Attachment 2 to AEP:NRC:1018

Proposed Revised Technical Specification Pages

AttachmentD.C. COOK UNIT 1 TECHNICAL SPECIFICATION CHANGE

DC Cook Unit 1 - Peak Pellet Burnup Extension

FIGURE 3.2-4
Exposure Dependent F_Q Limit, $F_Q^L(E)$, and Normalized Limit $T(E)$ as a function of Peak Pellet Burnup for Exxon Nuclear Company Fuel

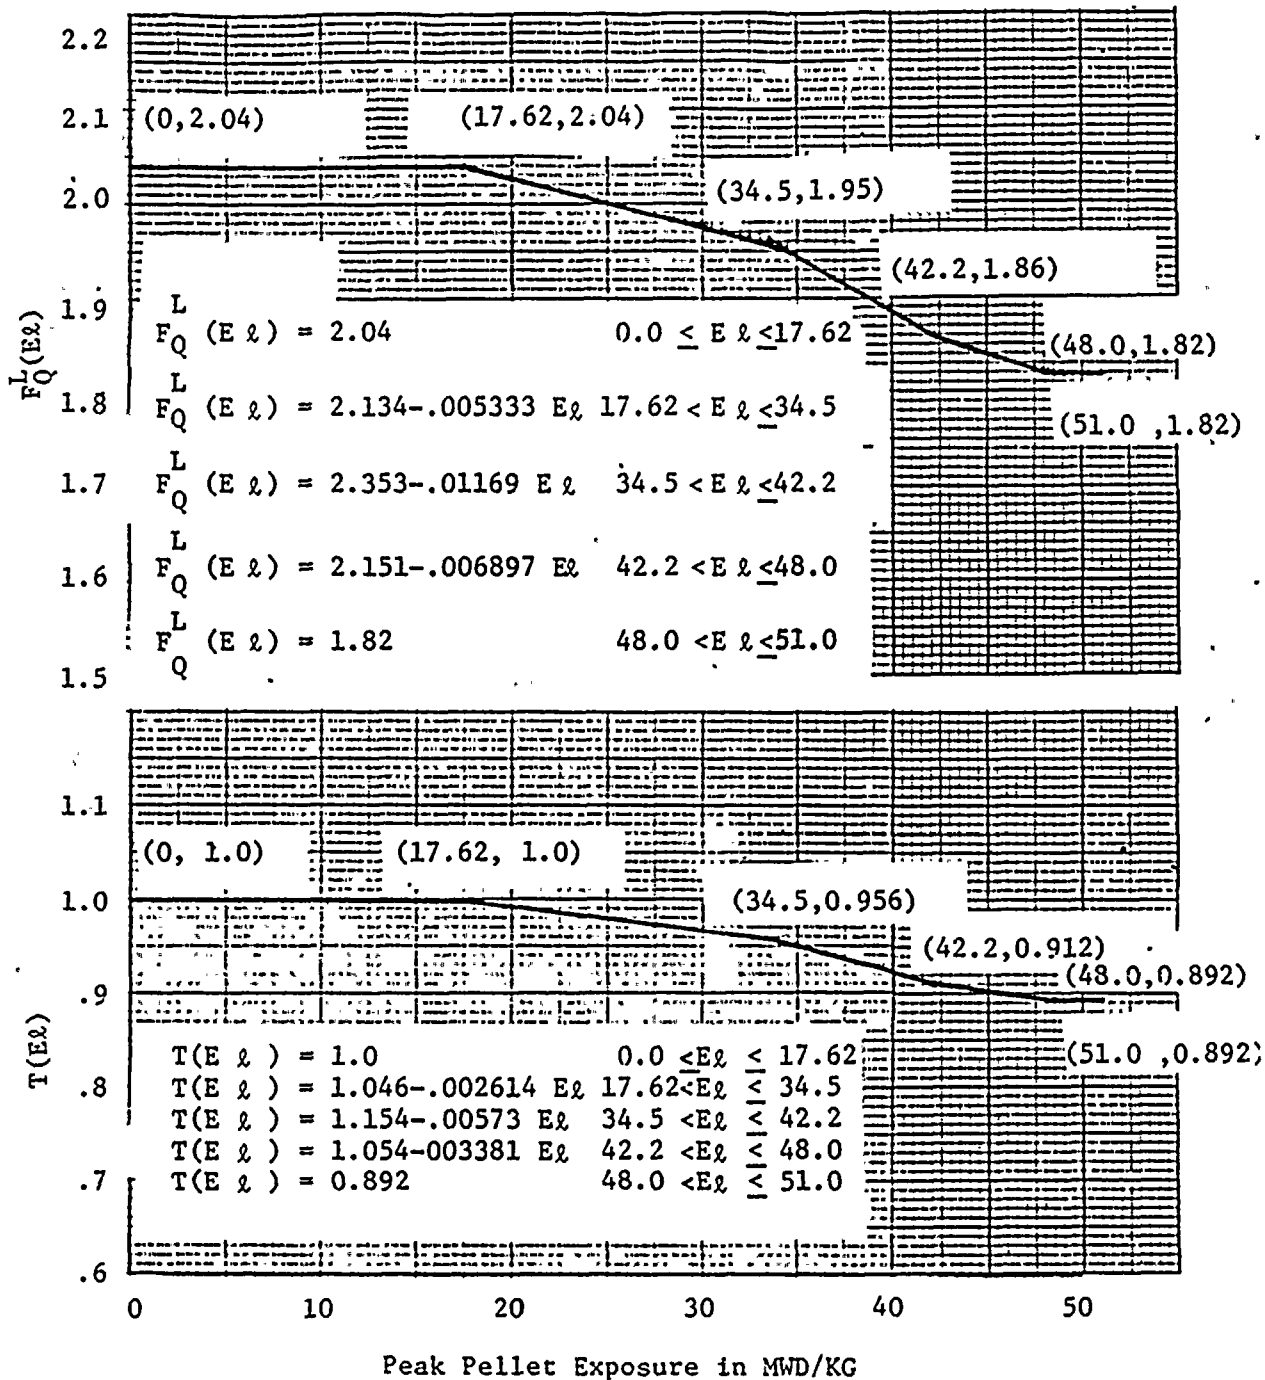
$V(Z)$ is a cycle dependent function and is provided in the Peaking Factor Limit Report. $K(Z)$ is defined in Figure 3.2-2 for Exxon Nuclear Company fuel and in Figure 3.2-3 for Westinghouse fuel. $T(E_\ell)$ is defined in Figures 3.2-4 and 3.2-5. $E_p(Z)$ is an uncertainty factor to account for the reduction in the $F_Q^L(E_\ell)$ curve due to accumulation of exposure prior to the next flux map.

Figure 1 Hot Channel Factor Normalized Operating Envelope, $F_Q=2.04$, $K(Z)$ Function

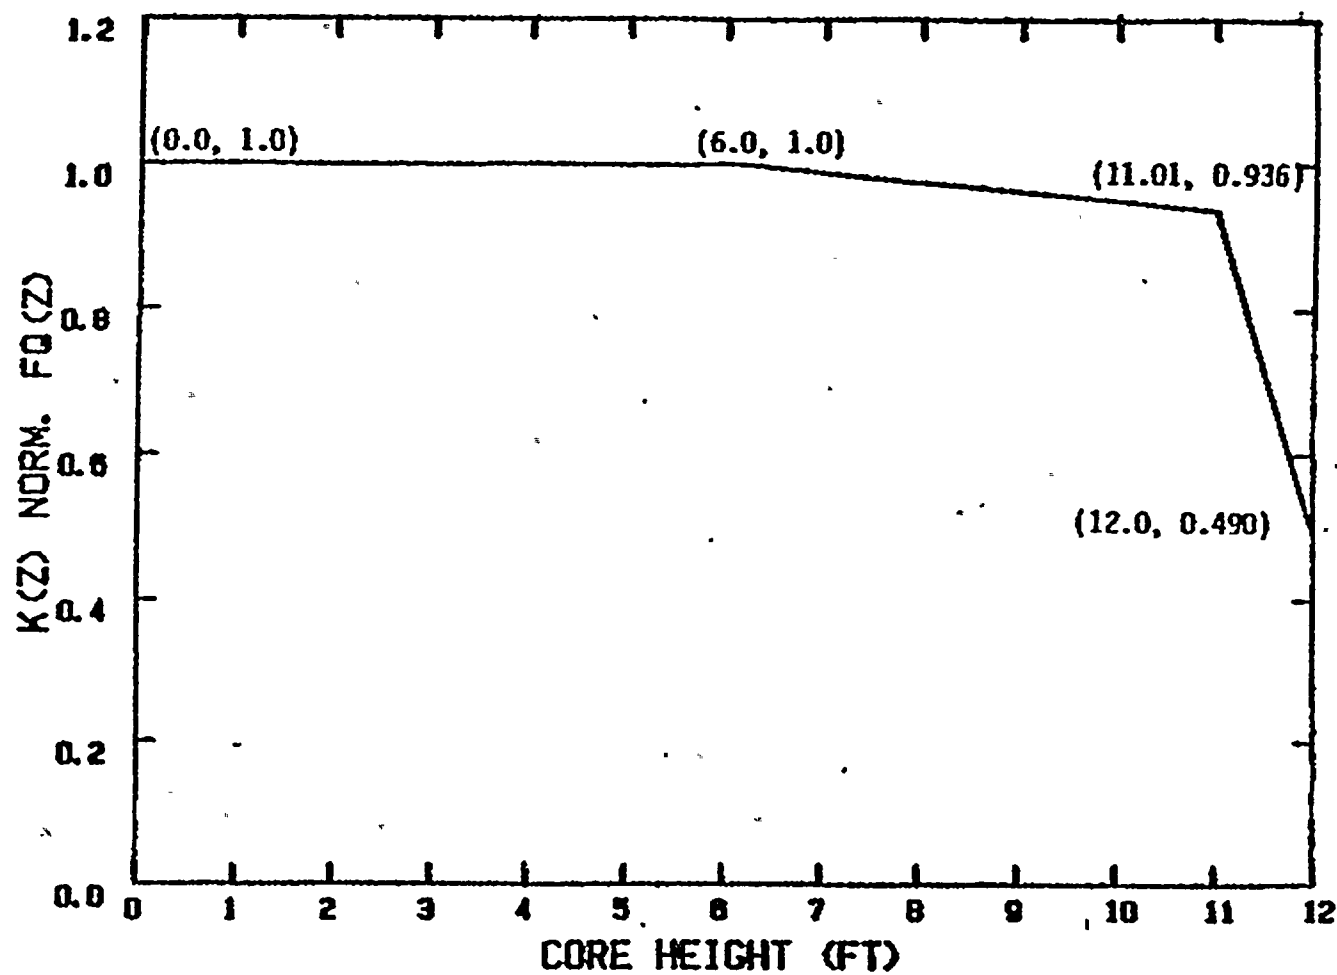
A LOCA/ECCS analysis justifying the operation of ENC fuel currently in the D.C. Cook Unit 1 reactor is presented in Reference 1. The analysis in that report supports a peak F_0 of 2.04 with an axial dependence as shown in Figure 1. This analysis is applicable to the ENC fuel currently in the D.C. Cook Unit 1 reactor, with a minimum peak rod average exposure greater than 20 GWd/MT and anticipated to be less than 47 GWd/MT.

Figure 3.2-4

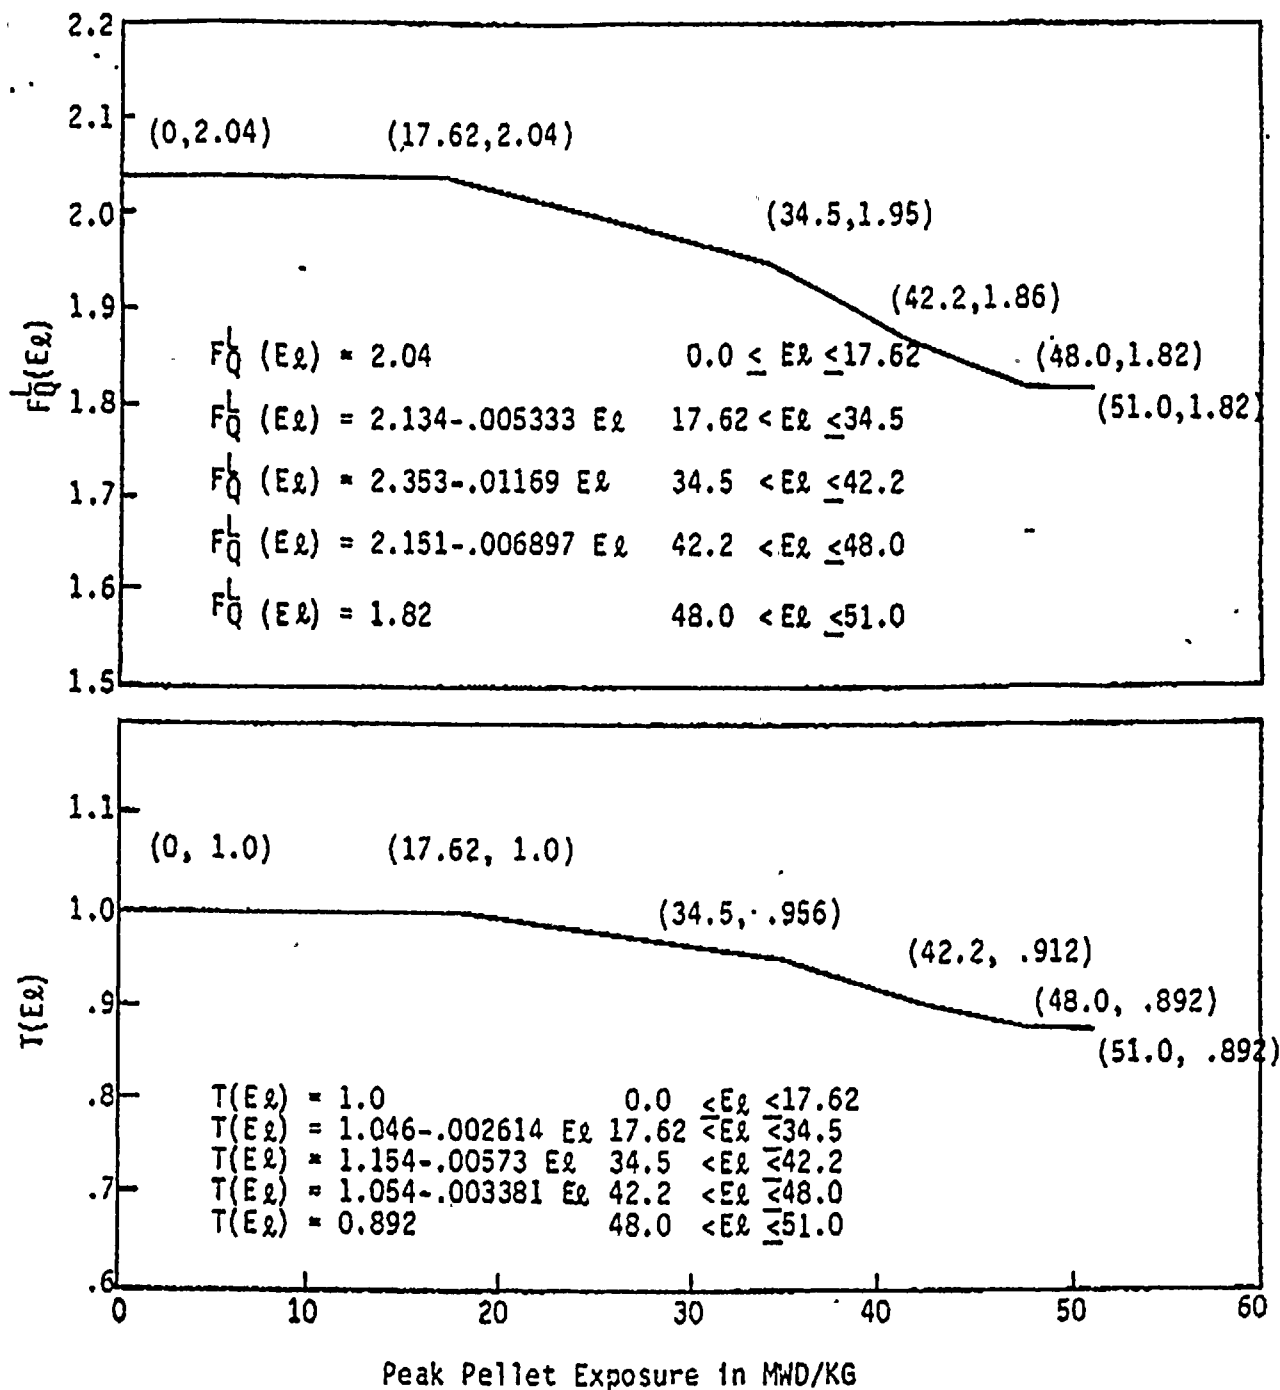
The recommended D.C. Cook Unit 1 exposure dependent F_0 Technical Specification Figure 3.2-4 is attached. This figure is the same as the figure in the current D.C. Cook Unit 1 Technical Specification but with the addition of a constant F_0 limit of 1.82 from 48.0 GWd/MT to 51 GWd/MT peak pellet exposure. For consistency with the current D.C. Cook Unit 1 Technical Specification, the curve has been maintained in terms of peak pellet burnup.
